The countryside charity

Kent

August 2024

The below is CPRE Kent's response to National Grid's (NG) project update and targeted consultation for Sea Link (July 2024 consultation).

Confirmation of the type of pylon

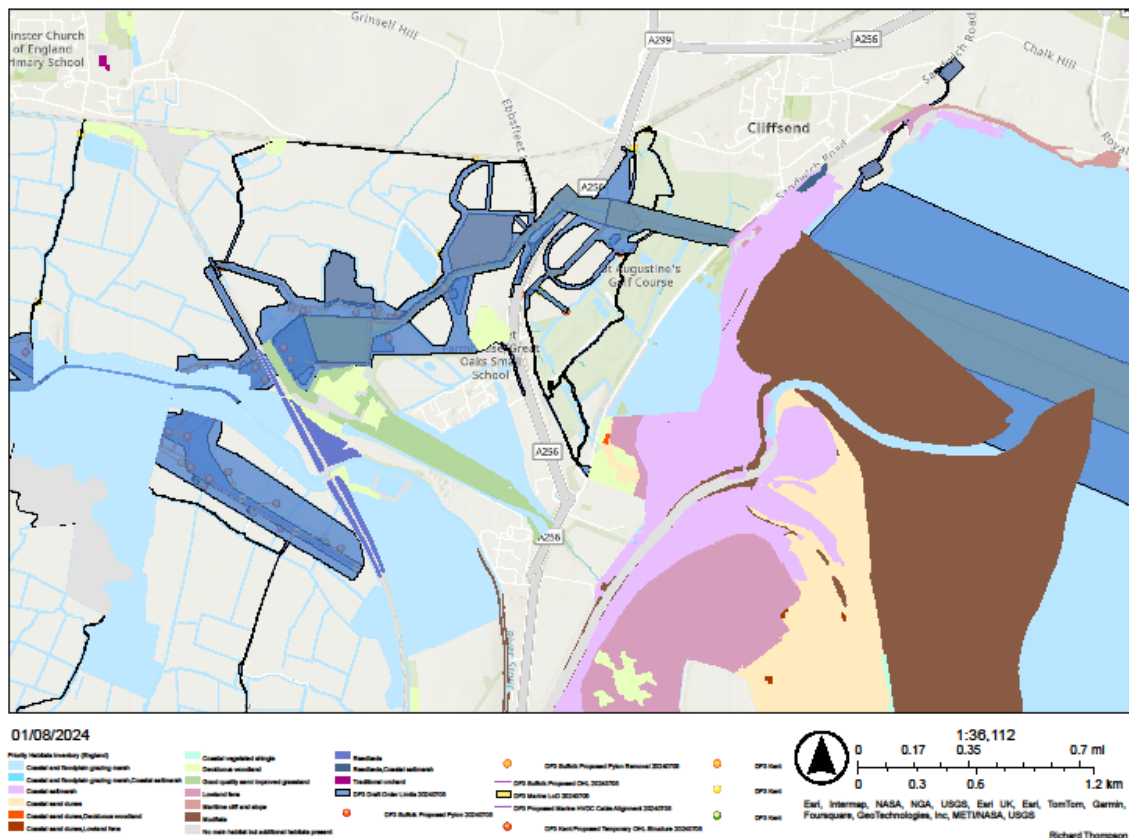
For the reasons set out above in relation to the converter station, clearly the landscape effect of the project will be greatly exacerbated through the use of overhead lines and pylons. This includes the introduction of temporary towers within the wetland area to facilitate the overhead-lines work.

It is noted that the increase in height and confirmation of pylon type and routeing results in an increase of 1.2 km in the total length of new overhead line compared with the proposals presented at the previous statutory consultation stage. Yet again this increase will clearly exacerbate the impacts previously raised. We are told that the main justification for this is to reduce the risk that birds could become trapped between the new and existing overhead lines. Nowhere, however, is this assertion evidenced. The simple fact is that this would not even be an issue if the lines were placed underground.

New access and compound off Sandwich Road

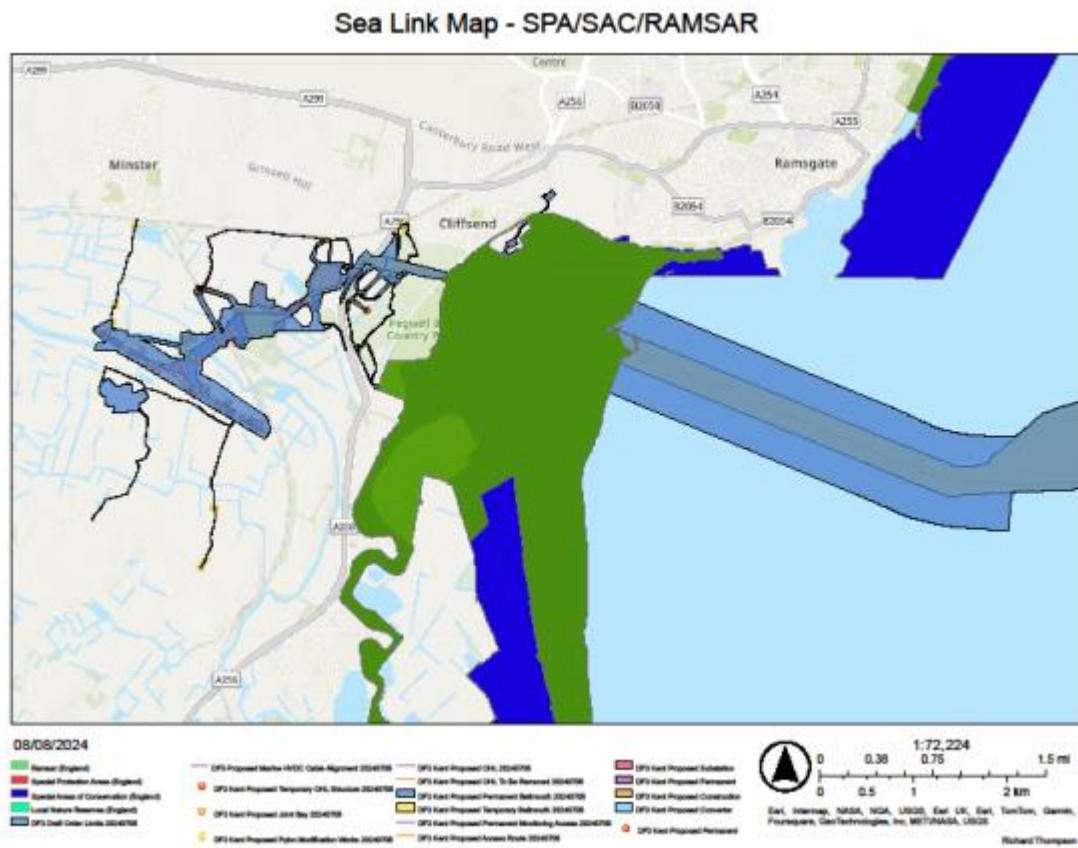
As set out within the detailed comments of CPRE Kent’s Ecologist below, we would question NG’s assertion that the new laydown areas on the hoverport and access off Sandwich Road are unlikely to introduce any new significant adverse effects. As shown below, one compound is adjacent and one is enclosed by the SPA/SAC/RAMSAR boundary, and the track will dissect it. Far more information will therefore be required at the Environmental Statement (ES) stage to convince us that there will be no significant effect.

Sealink Order Limit against CPRE Dark Sky Map

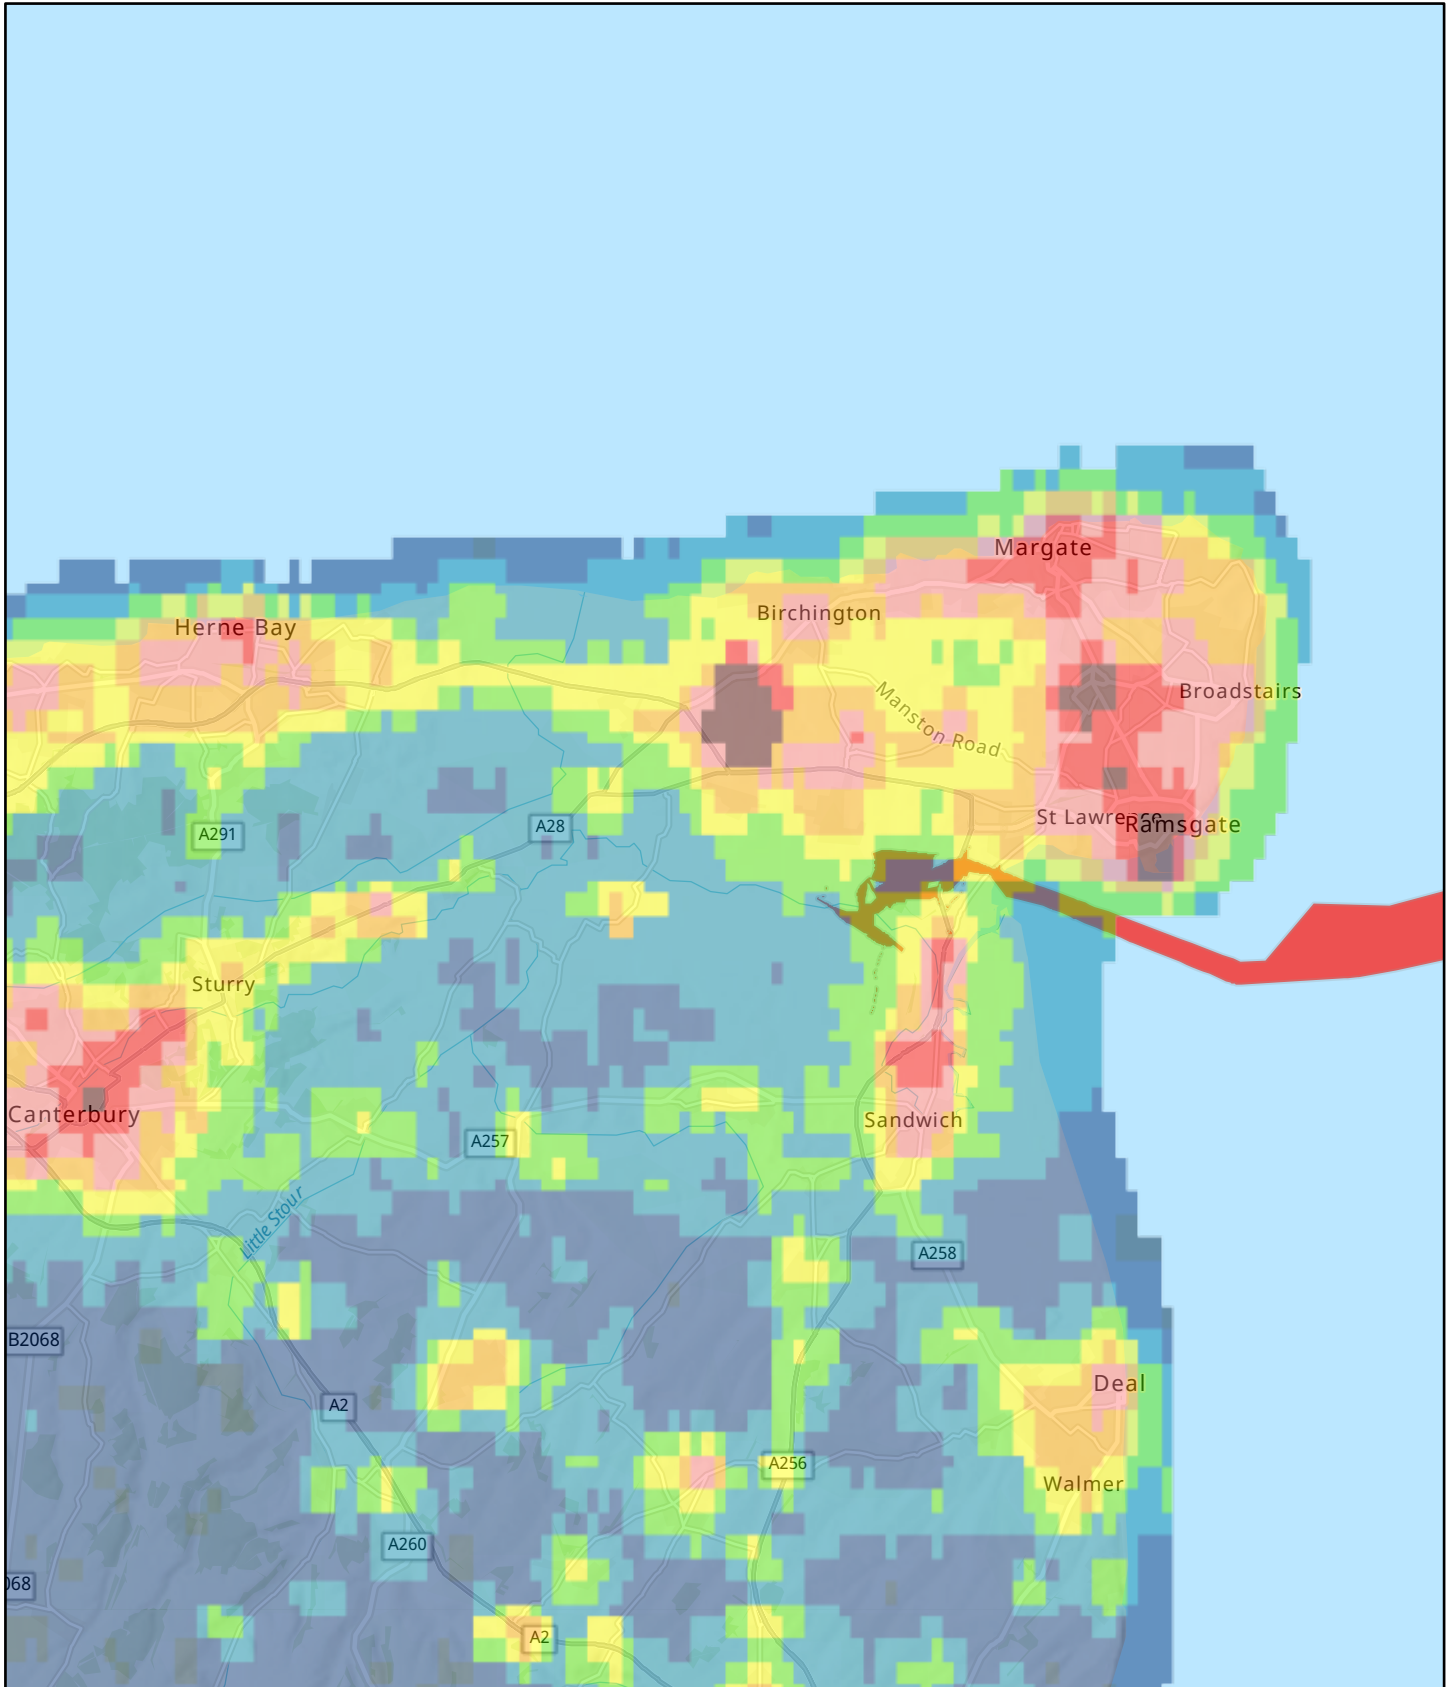
The proposed location is within one of the few remaining areas of darker skies within the Thanet District as shown within CPRE Dark Sky mapping (appended below). It is therefore deeply concerning that this very significant constraint has been given little to no consideration within the various PEIRs.
